DEPARTMENT REPORT

12/18/2025

SUBJECT: H-2025-0047

Shafer View Ridge Subdivision AZ, PP

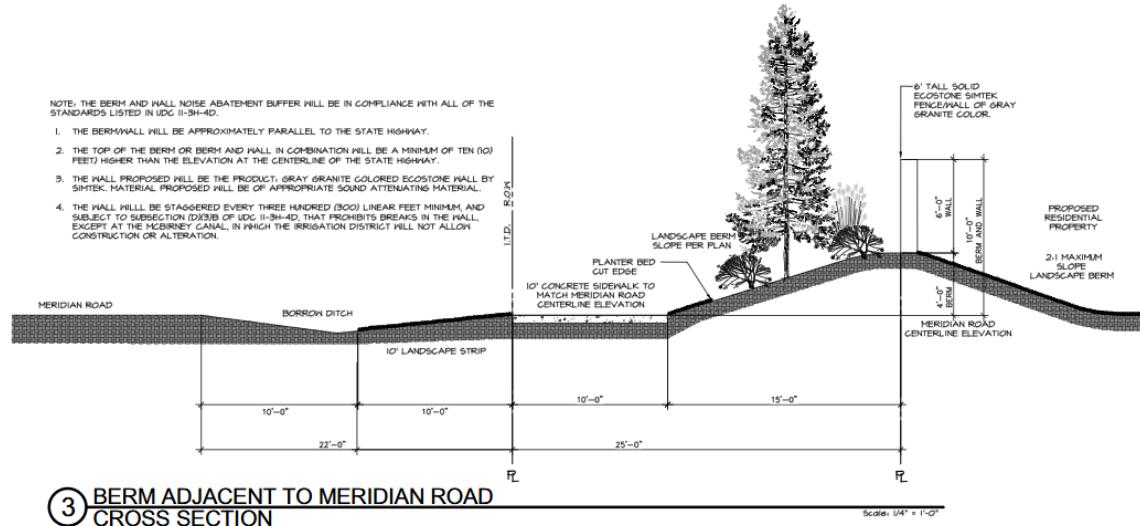
The applicant states this requirement can be met using the existing cut bank along Meridian Road, which will act as a berm, in combination with a wall extending 10 feet above the highway centerline. The fence will be designed to incorporate architectural elements and to break up monotonous wall planes as required. See berm cross section below.

D. Preliminary Plat (date: 9/8/2025)

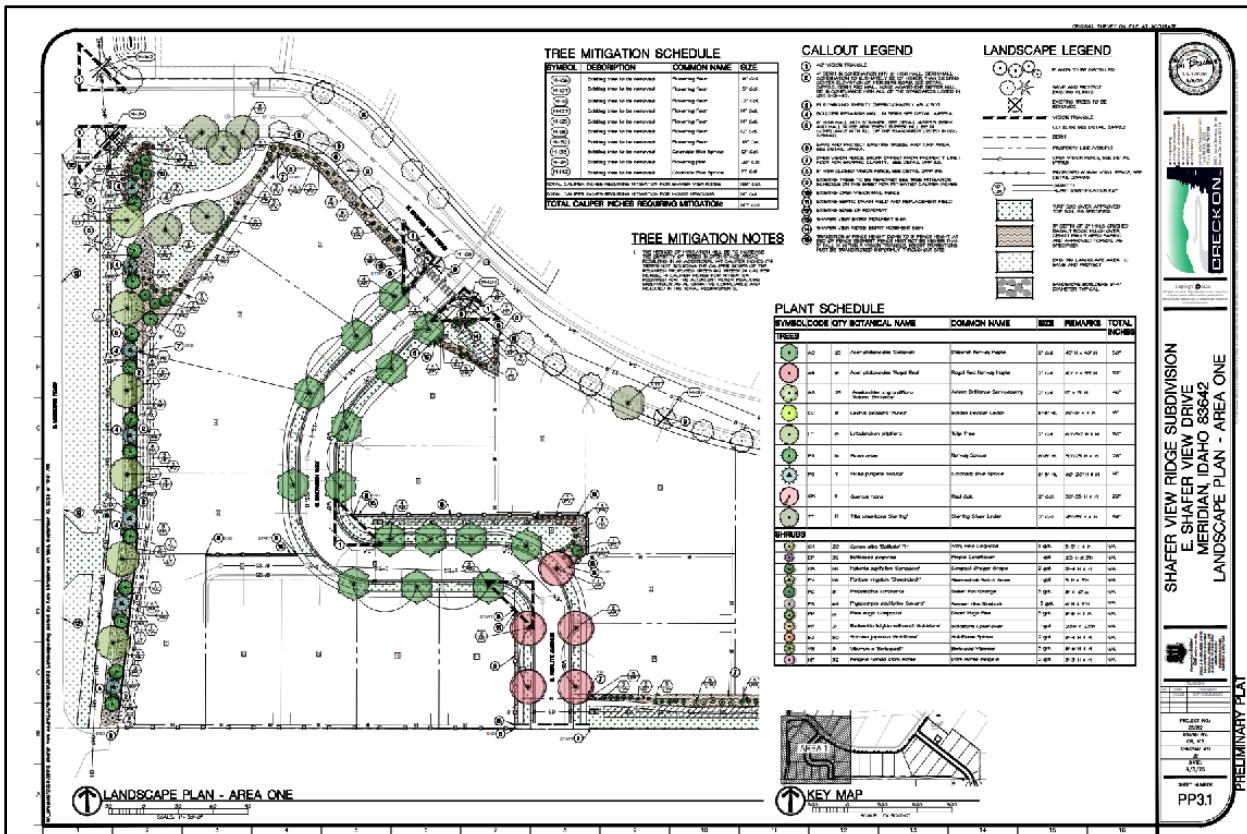
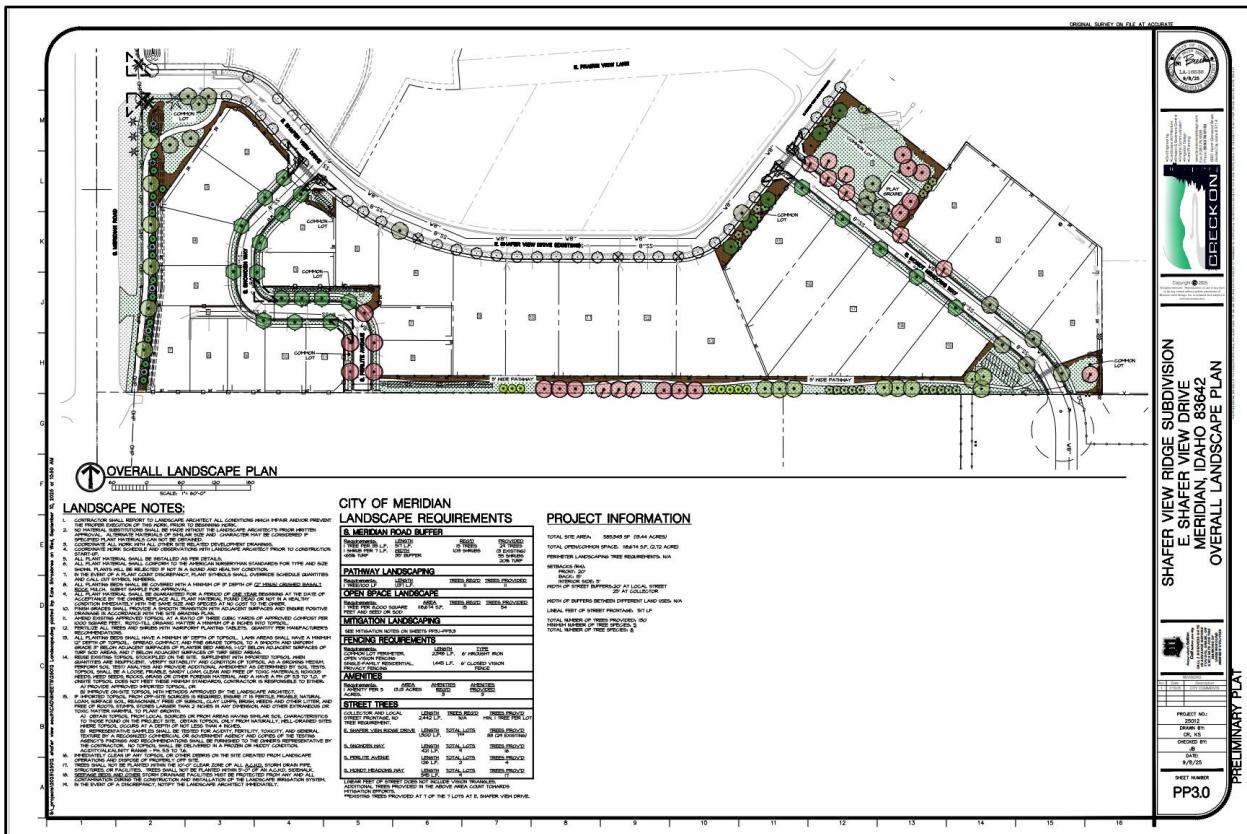
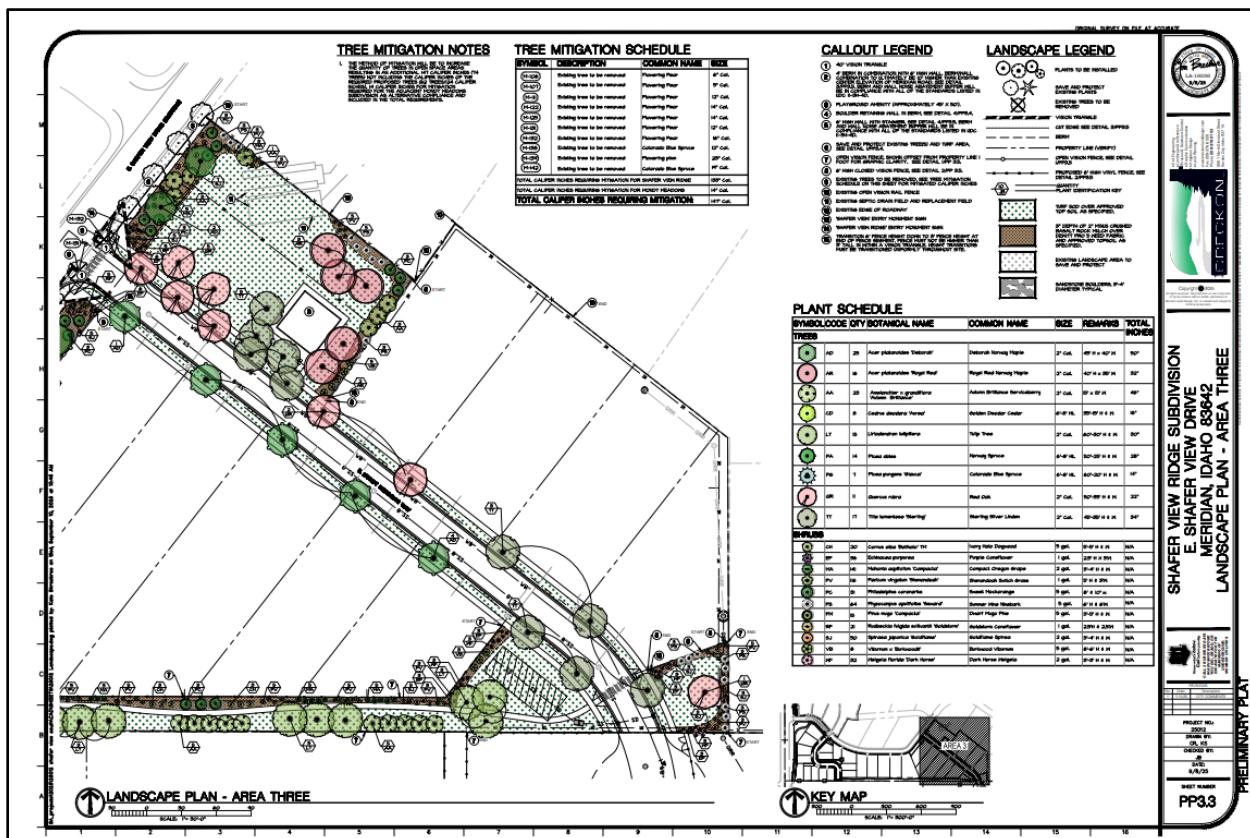
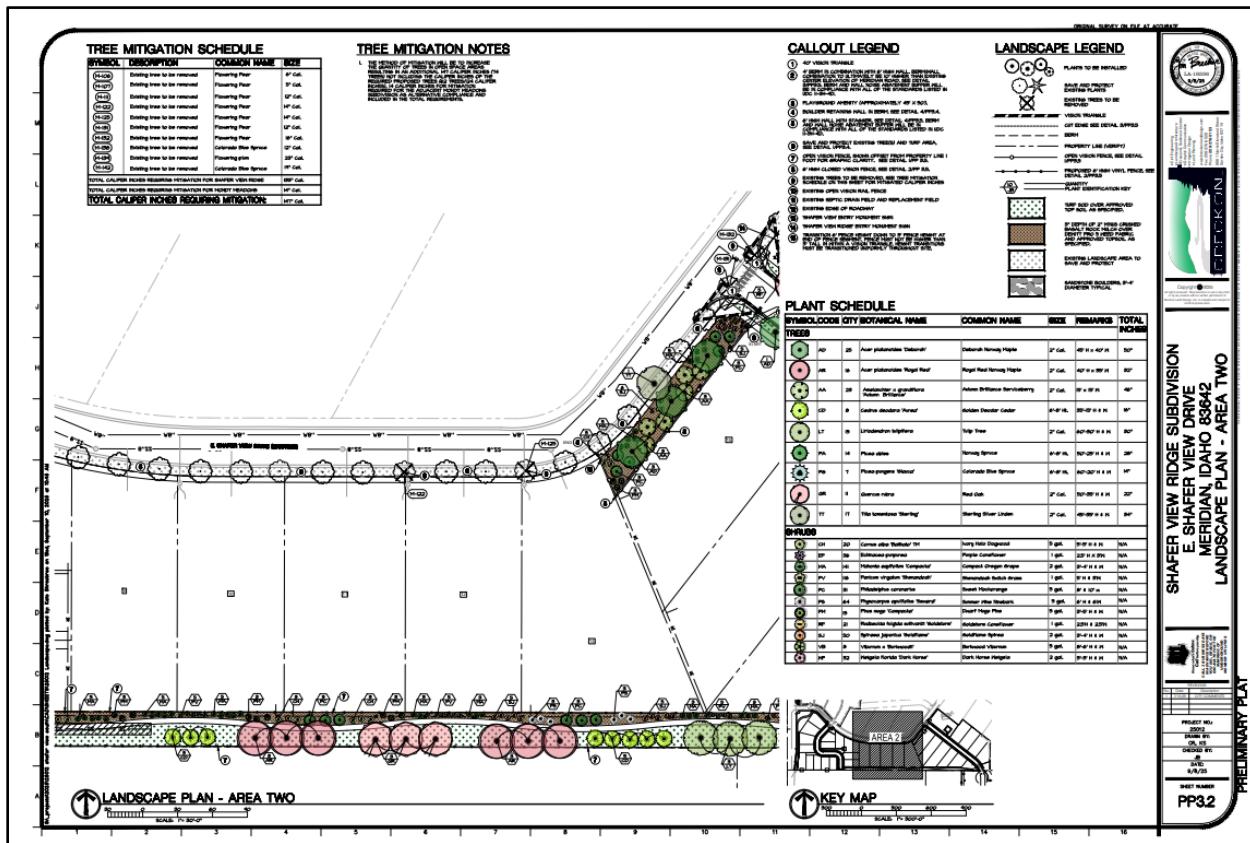
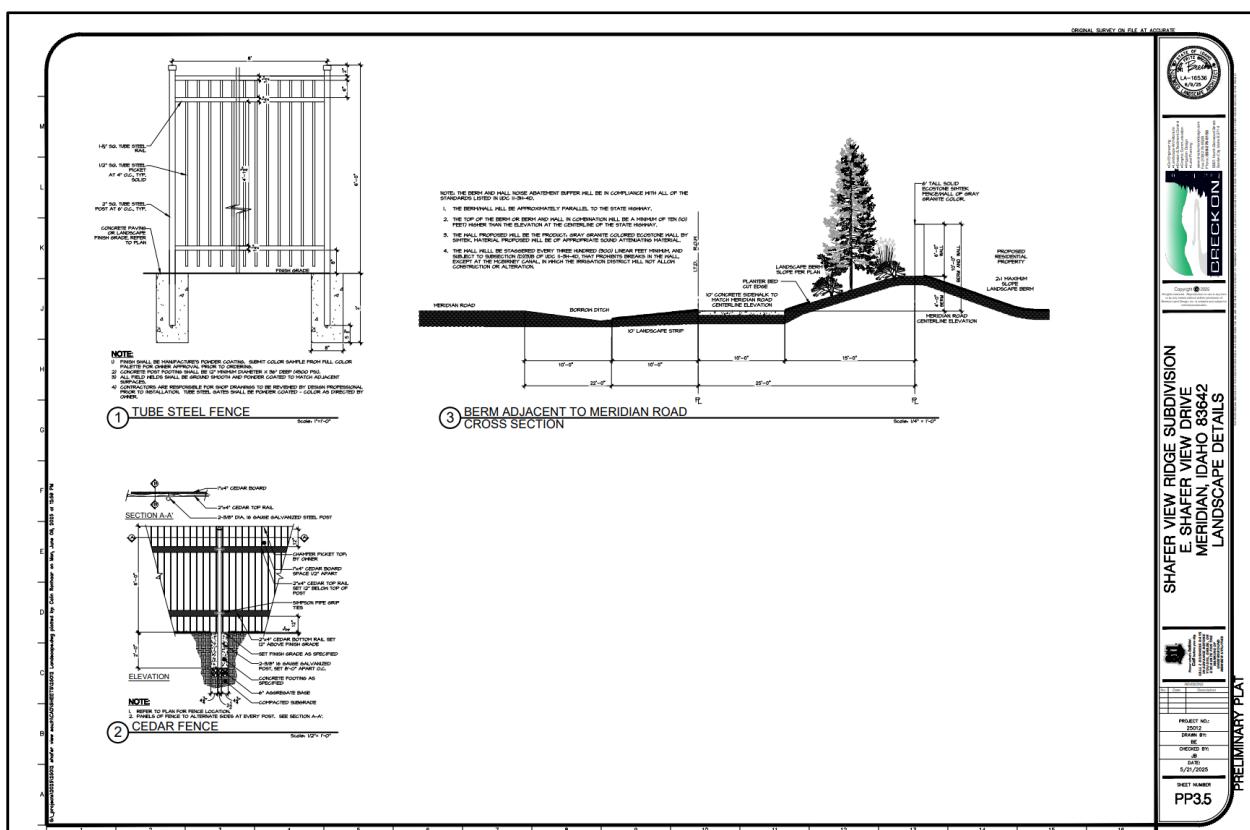
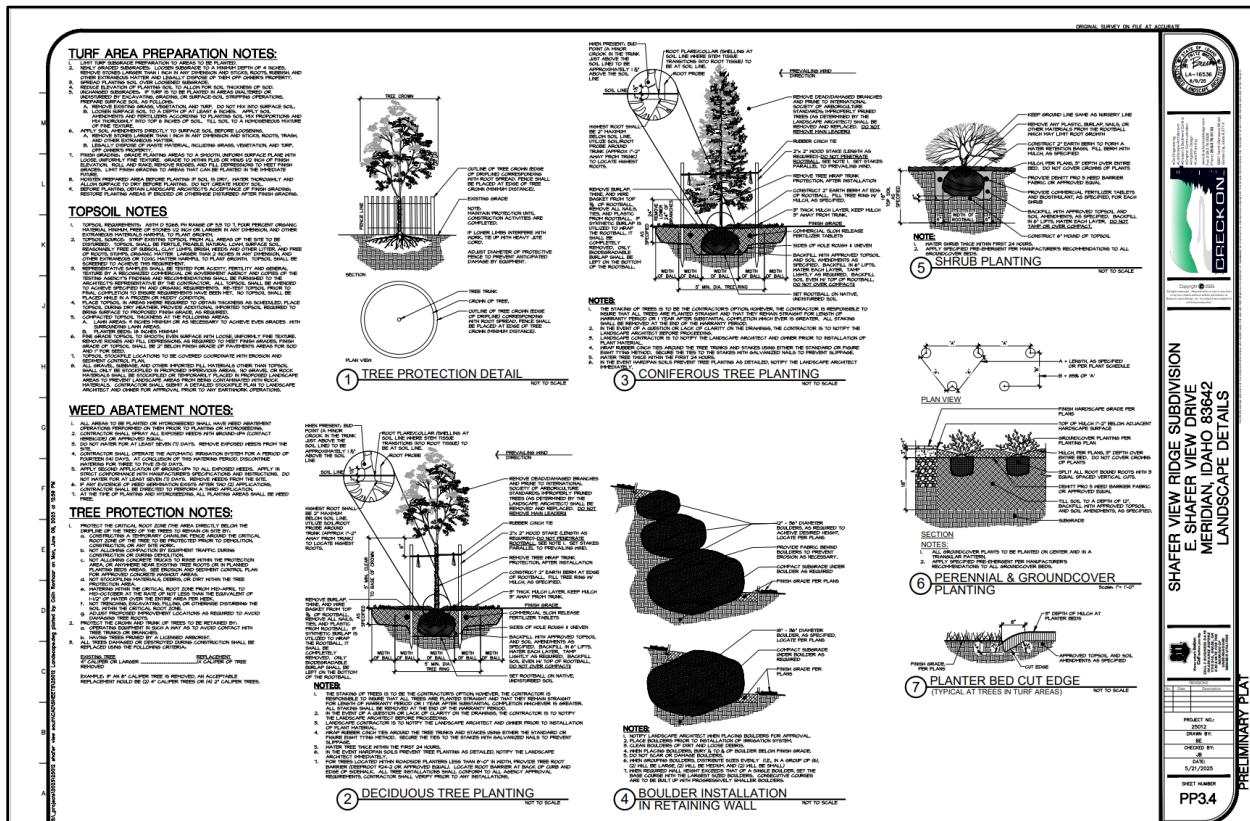
- g. Any future development of the site must comply with the City of Meridian ordinances in effect at the time of the development.
2. Submit the following revisions for the Preliminary Plat included in Section VII, dated 4/7/25:

- a. Revise the plat map to depict the dry ditch on parcel # S1131346650 and its associated easement or provide written documentation showing the dry ditch had been abandoned and is no longer in use by the affected property owners.

F. Amenity Exhibit (date: 9/8/2025)

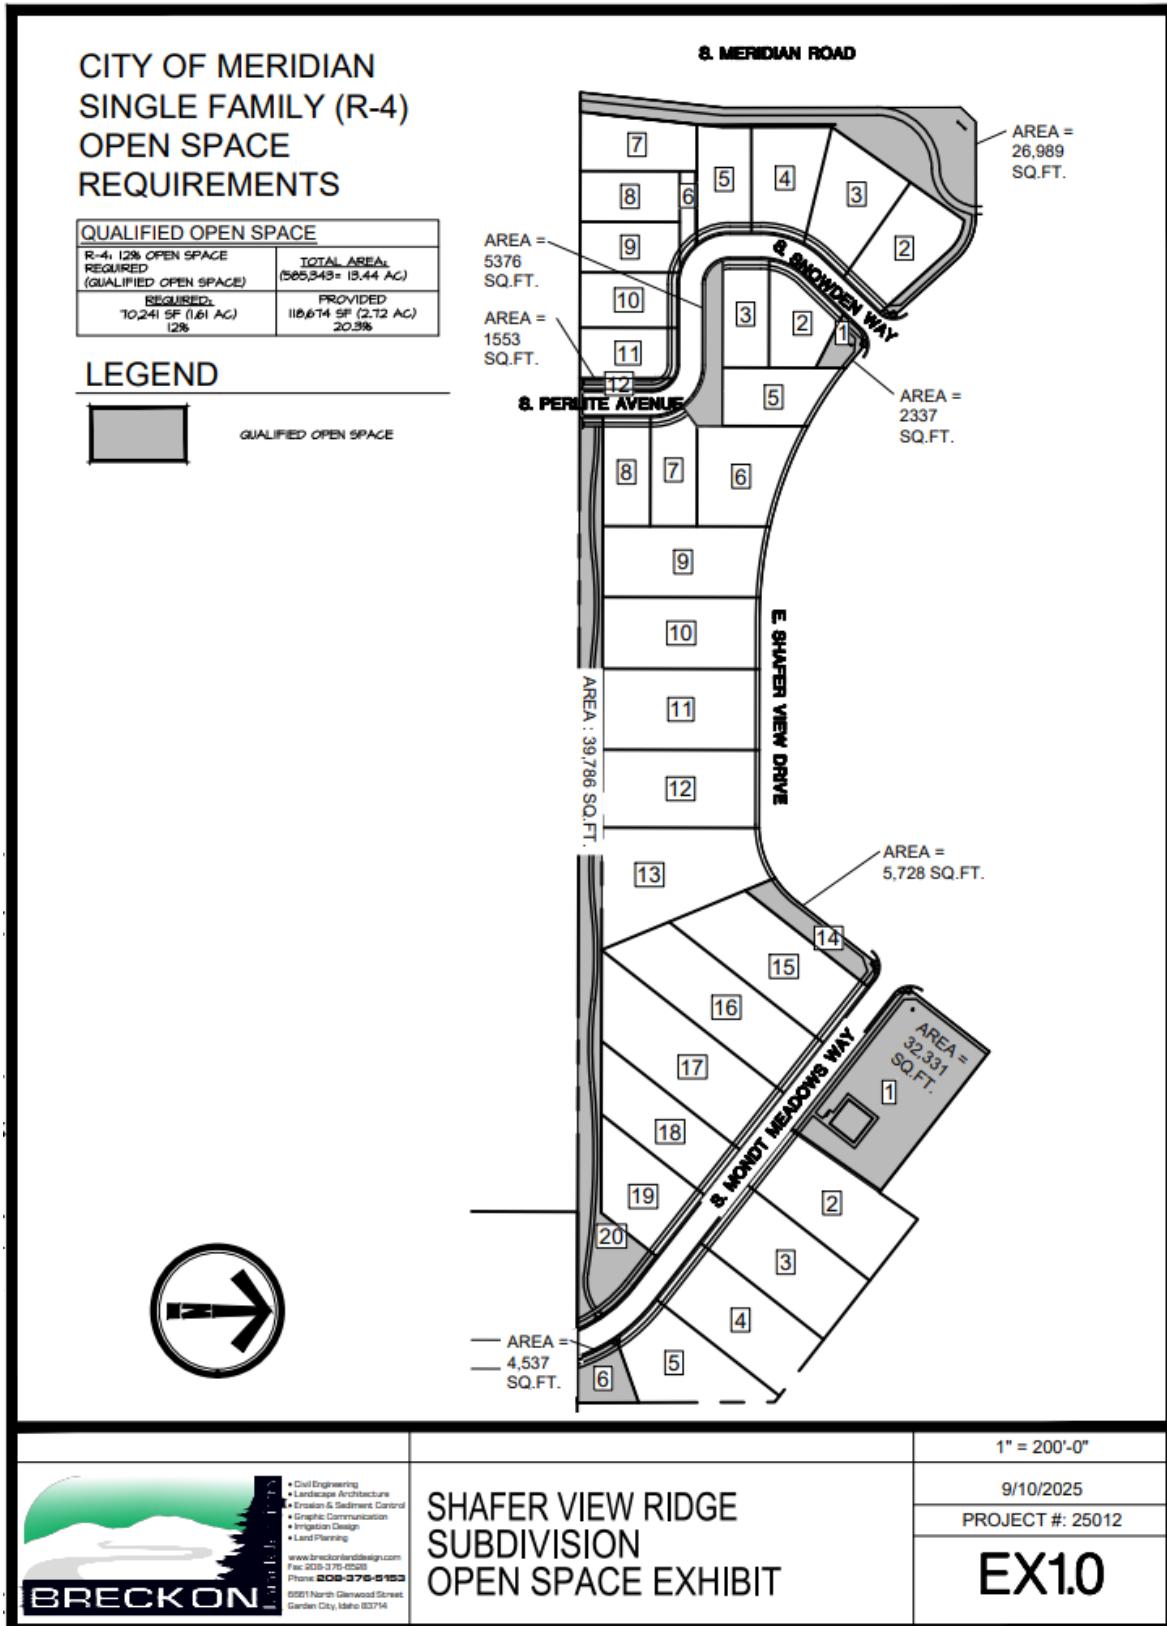
- c. Direct lot access to S. Meridian Road is prohibited.
 - d. No building permits shall be issued prior to the plat being recorded.
 - e. The Open Space amenities shall meet the following requirements: provide a playground and bench as depicted in Exhibit VIIIF.

H. Block Length Exhibit (date: 9/3/2025)

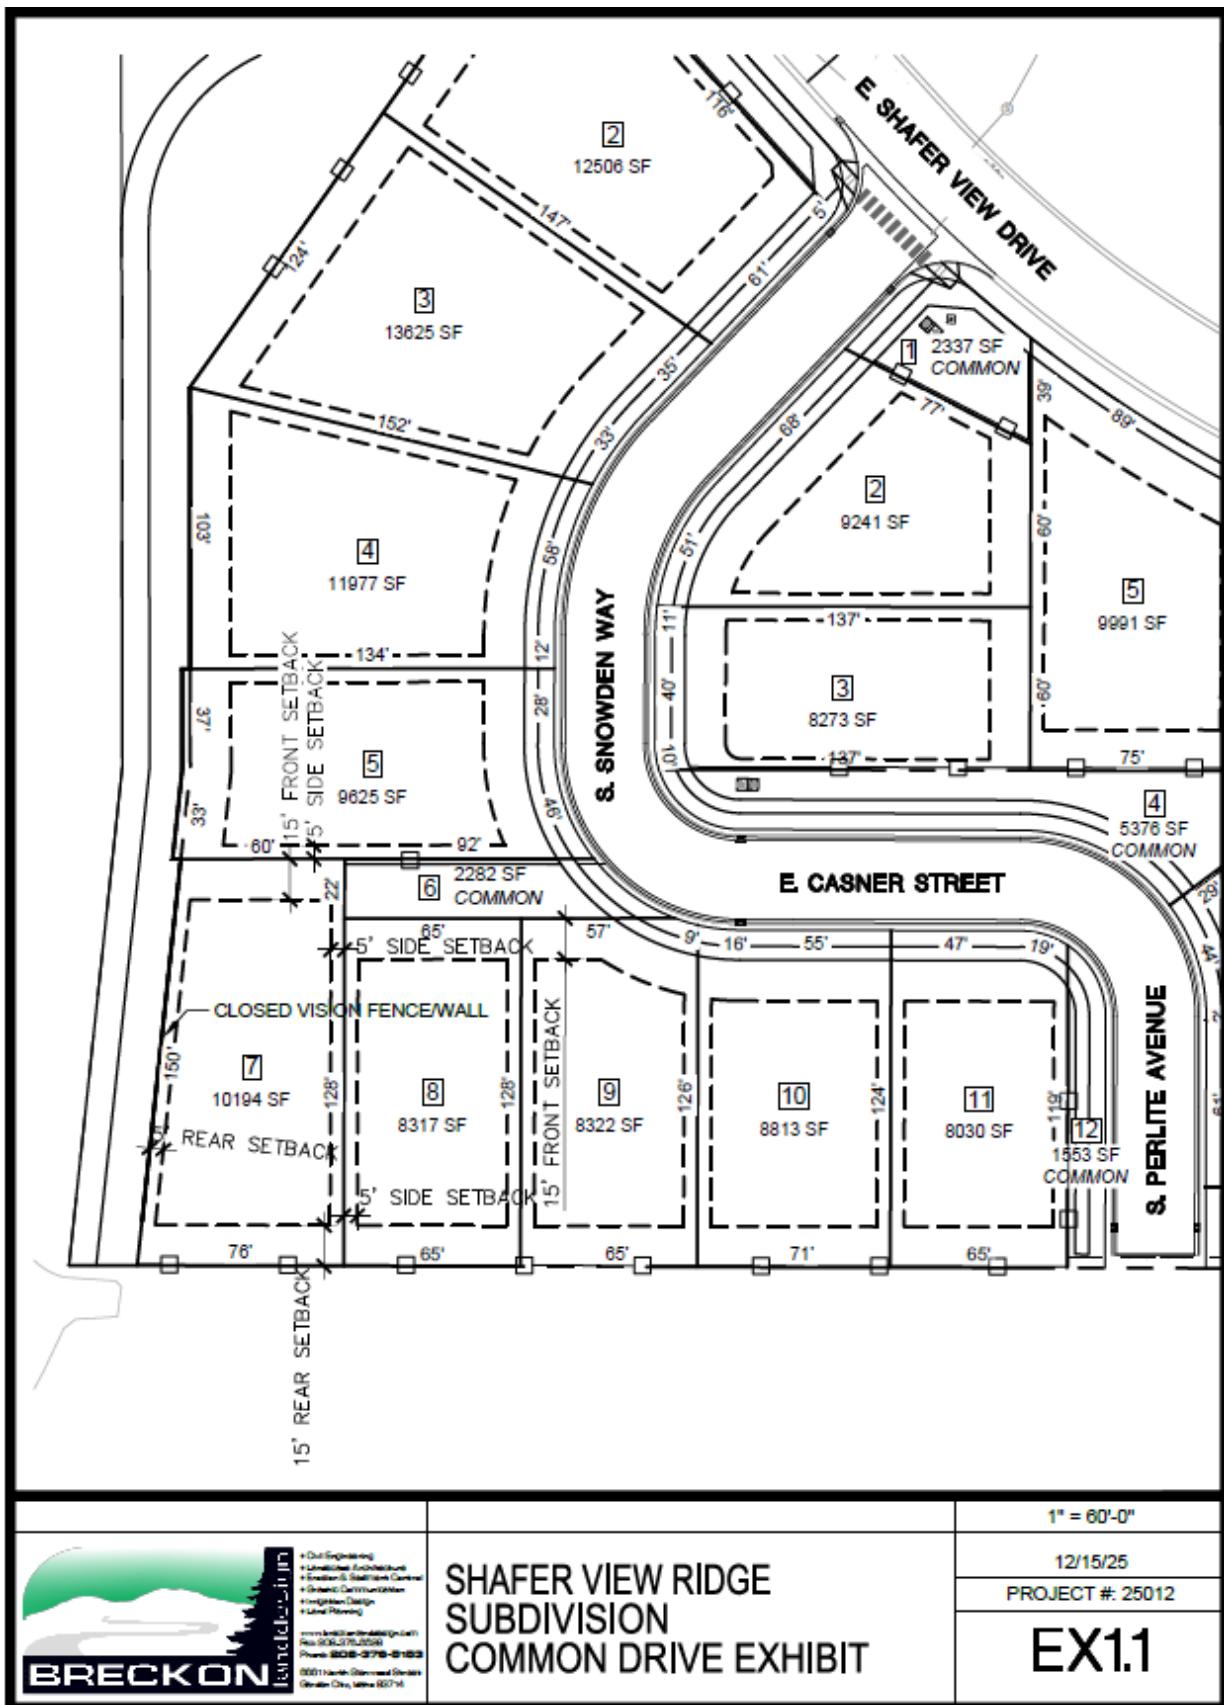
The existing street, Shafer View Drive, measures approximately 1,194 feet along the north side and approximately 873 feet along the south side, both of which exceed the maximum block length standard of 750 feet as established by the Unified Development Code (UDC). As a result, the block does not fully comply with the UDC block length requirements intended to promote walkability, pedestrian connectivity, and an interconnected street network.

Accordingly, the applicant is requesting a waiver from City Council to allow the block face to exceed the maximum block length standard. This request is based on the existing configuration and alignment of Shafer View Drive, which was constructed within Ada County prior to the current development proposal and outside the context of the City's adopted block length standards. The applicant has stated that the size and irregular shape of the subject property, combined with the proposed residential lot layout and lot sizes, limits the ability to further subdivide the block.

Pursuant to UDC 11-6C-3.F.3.a, block faces within residential zoning districts may be extended up to one thousand (1,000) feet when a pedestrian connection is provided to maintain connectivity for non-vehicular travel. In support of this standard, the applicant has provided a detached sidewalk along the south side of E. Shafer View Drive, which establishes a continuous pedestrian connection through the subdivision and enhances access for pedestrians. While the north block face exceeds the one-thousand-foot allowance, the provision of pedestrian infrastructure helps mitigate the impacts associated with the extended block length by supporting safe and convenient pedestrian movement consistent with the intent of the UDC.
